**TITLE: NAVIGATION - GENERAL - REPLACE AOA PROBE CONIC PLATE BY
AOA PROBE FLAT PLATE**

MODIFICATION No.: 203295S32646

SERVICE BULLETIN No.: A340-34-4273

REVISION No.: 00 - Jan 30/13

Figure A-FSBAA - Sheet 01

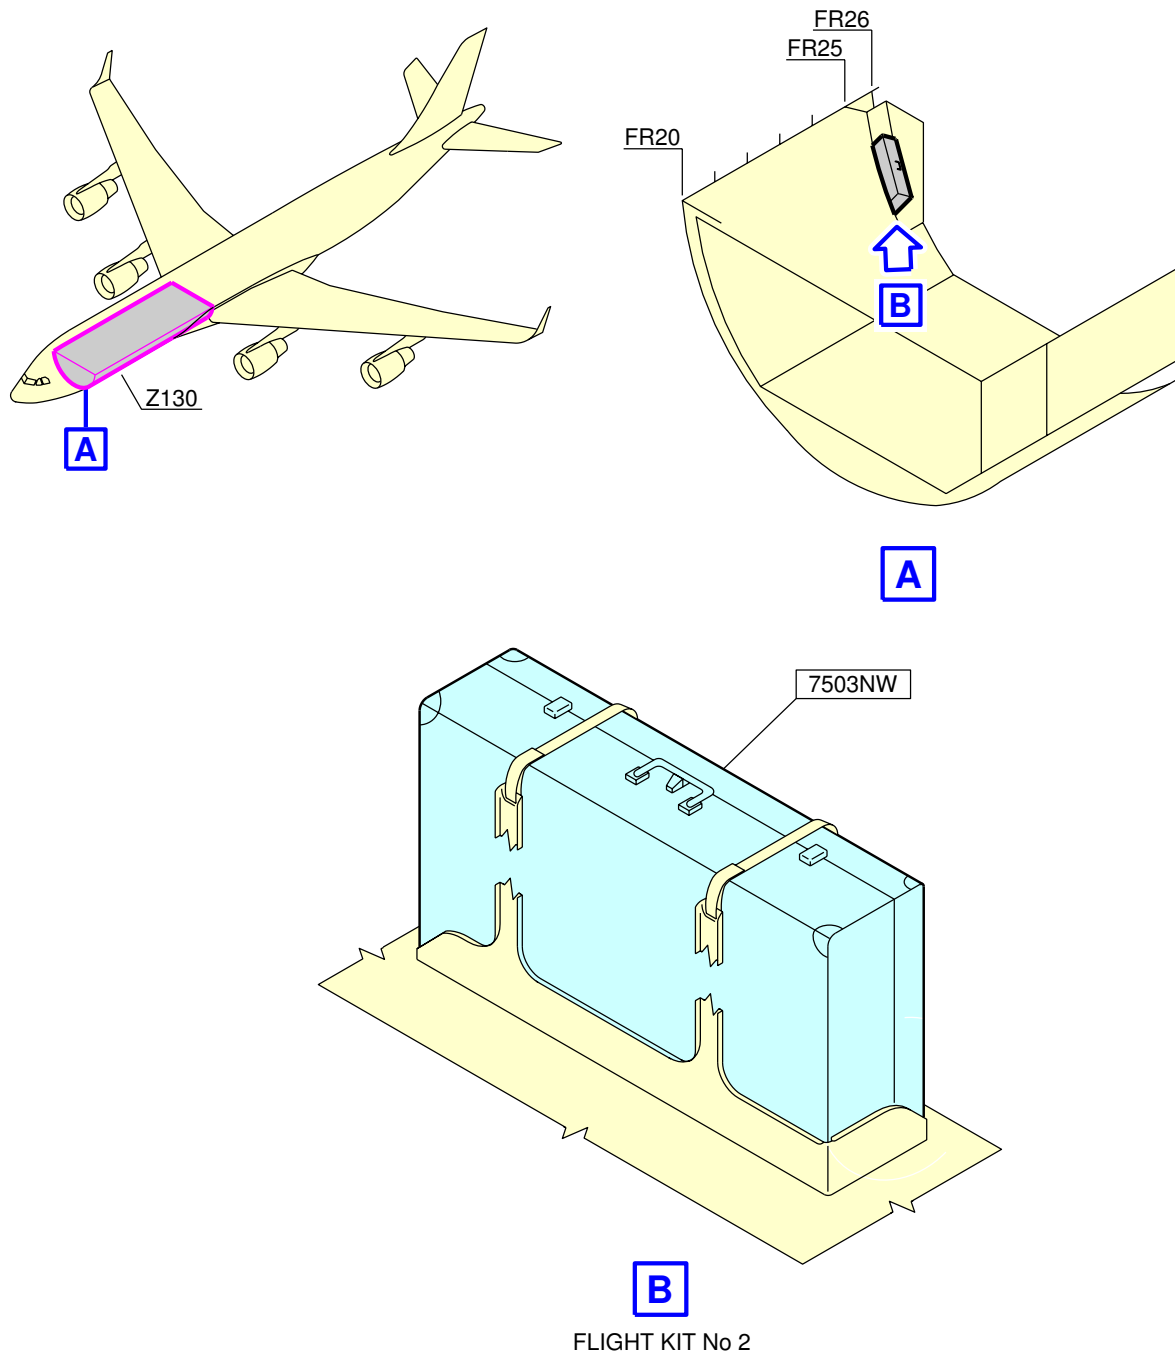
AOA PROTECTION COVERS FINs (7955ME, 7956ME AND 7957ME)
ARE STORED IN FLIGHT KIT No 2 FIN (7500NW)

Figure A-FBAAA - Sheet 01
Modification of the Plates

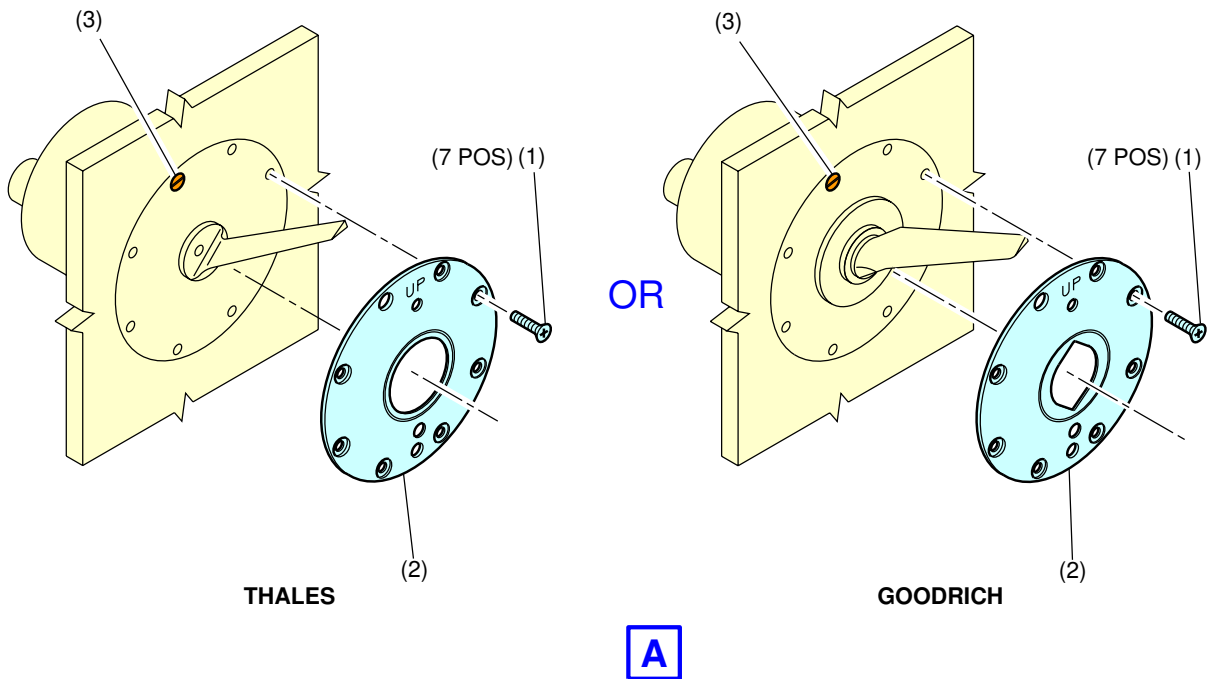
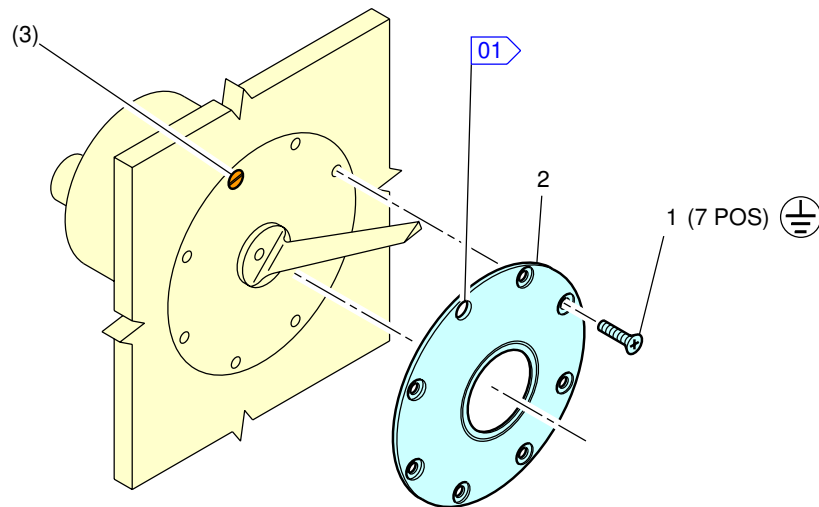
(a) Replace the conic plate by the flat plate of the AOA Sensor FIN 3FP1:

2 Remove the conic plate:

- (b) Blank off the hole located in front of the screw item (3) in accordance with SRM 51-24-00 and as shown on [Fig. A-FBAAA Sheet 02](#) with:

Figure A-FBBAA - Sheet 01
Modification of AOA Protection Covers in the Flight Kit No 2

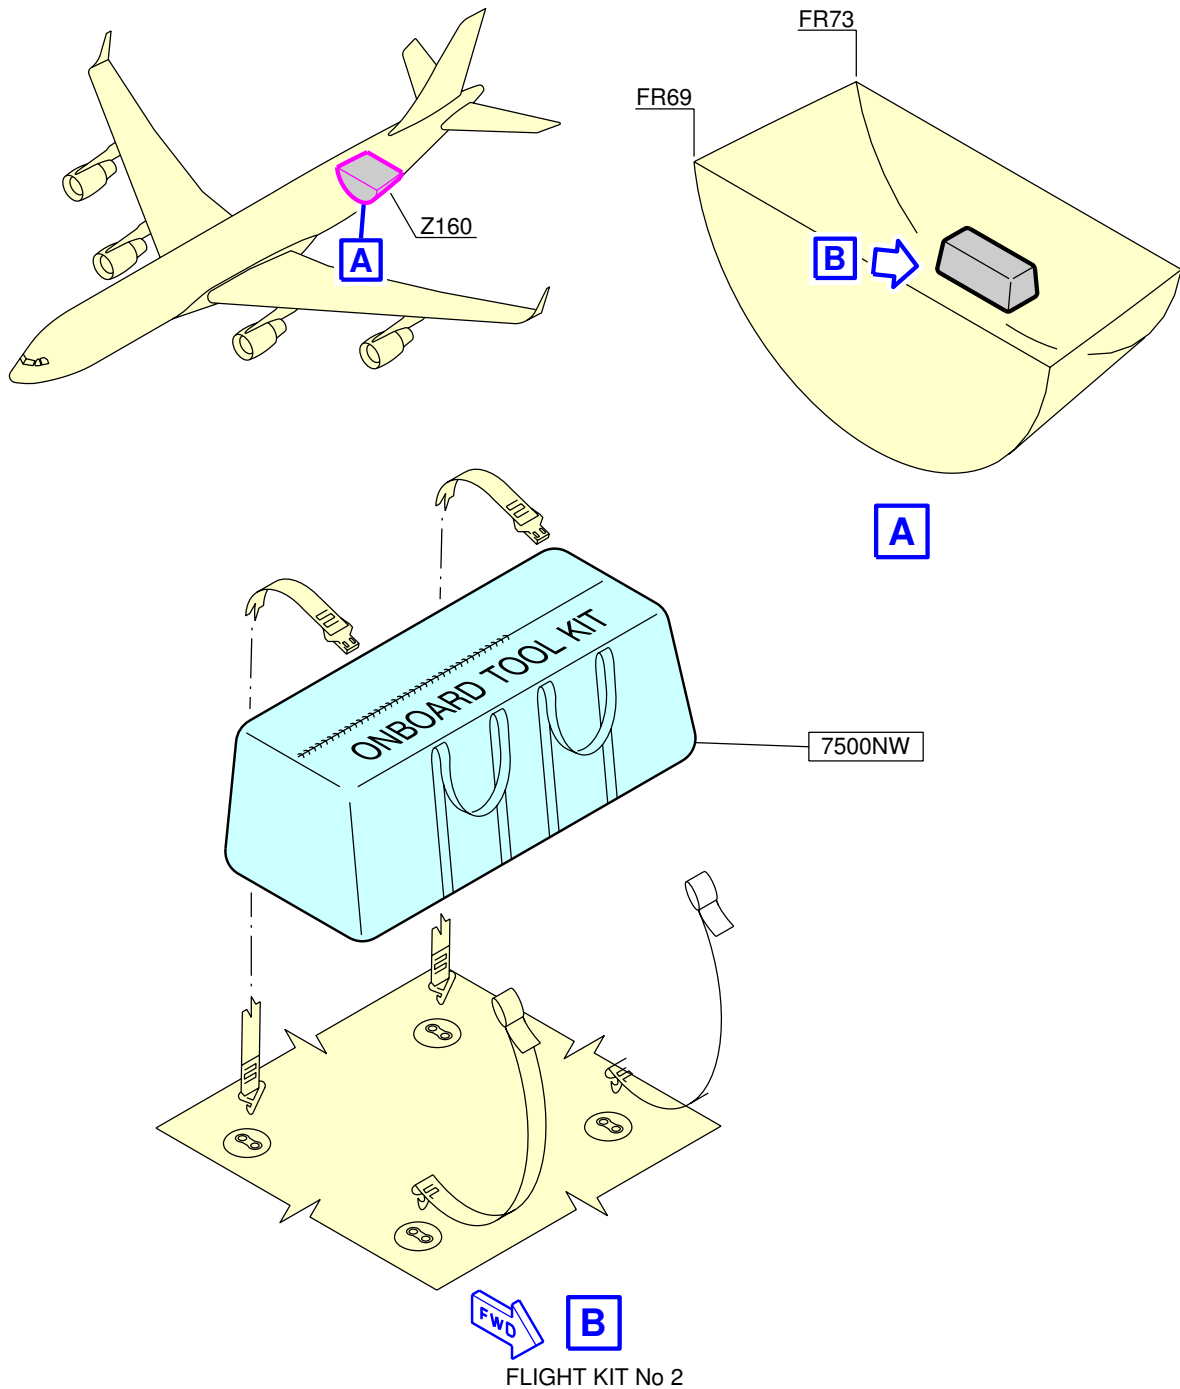
Also, it requires to change the 3 AOA Sensor Protection Covers (FINs 7955ME, 7956ME and 7957ME) stored in Flight Kit No 2 (FIN 7500NW or FIN 7503NW).

(a) Remove in the Flight Kit No 2 (FIN 7500NW):

Figure A-FBBAB - Sheet 01
Modification of AOA Protection Covers in the Flight Kit No 2

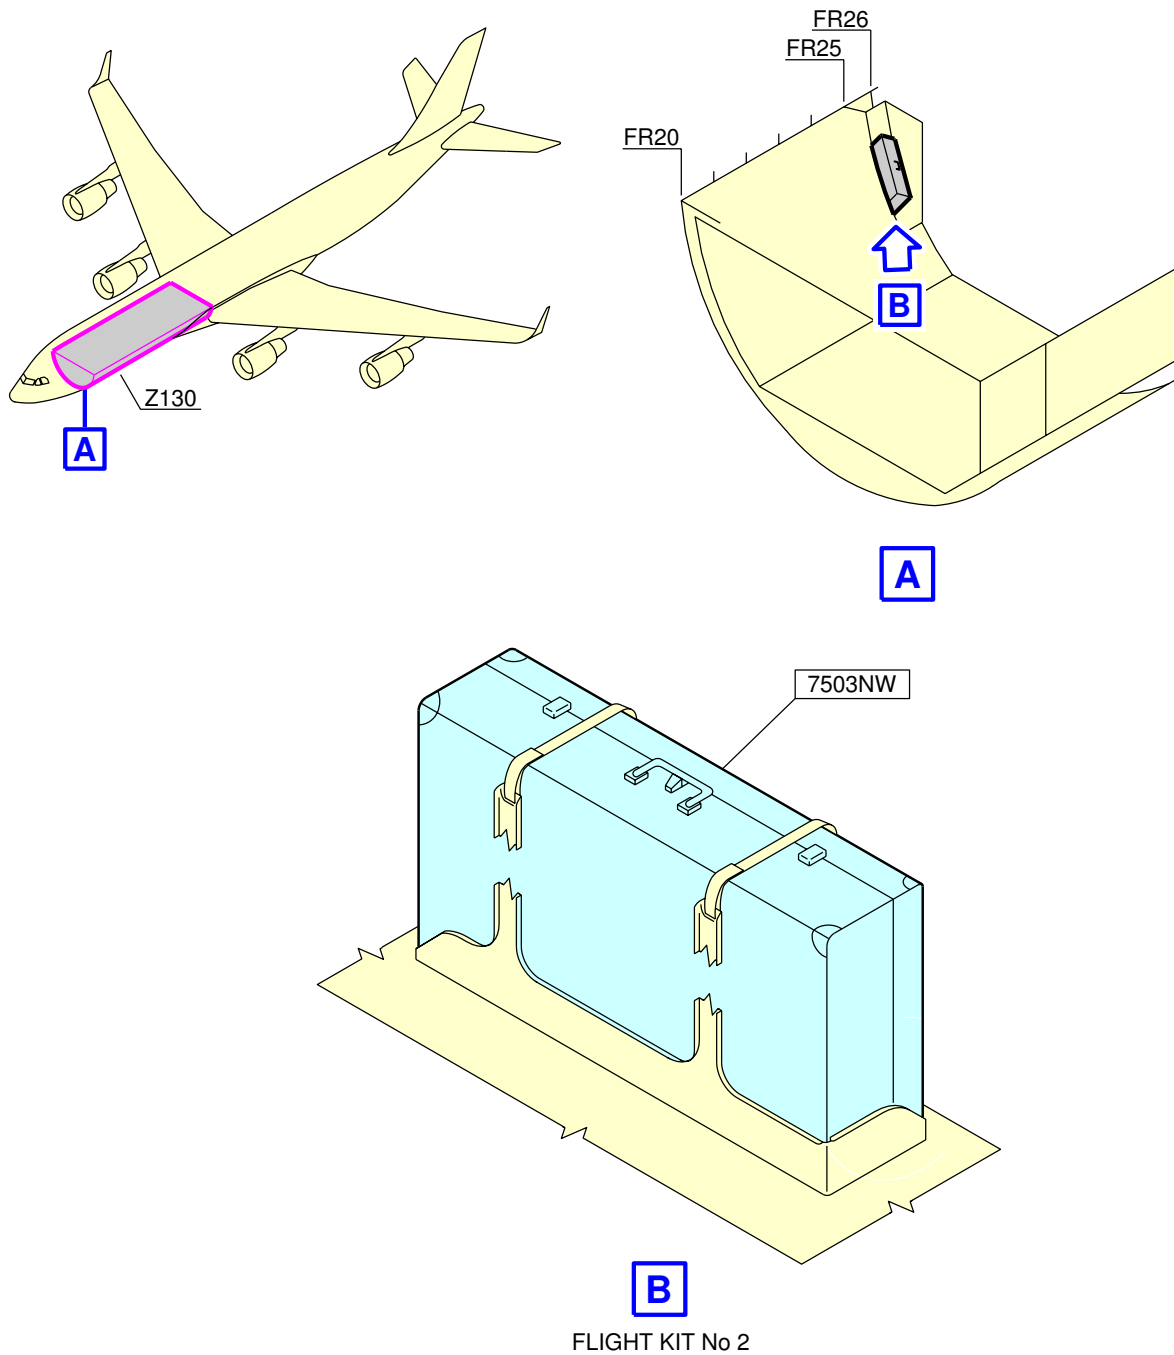
(a) Remove in the Flight Kit No 2 (FIN 7503NW):
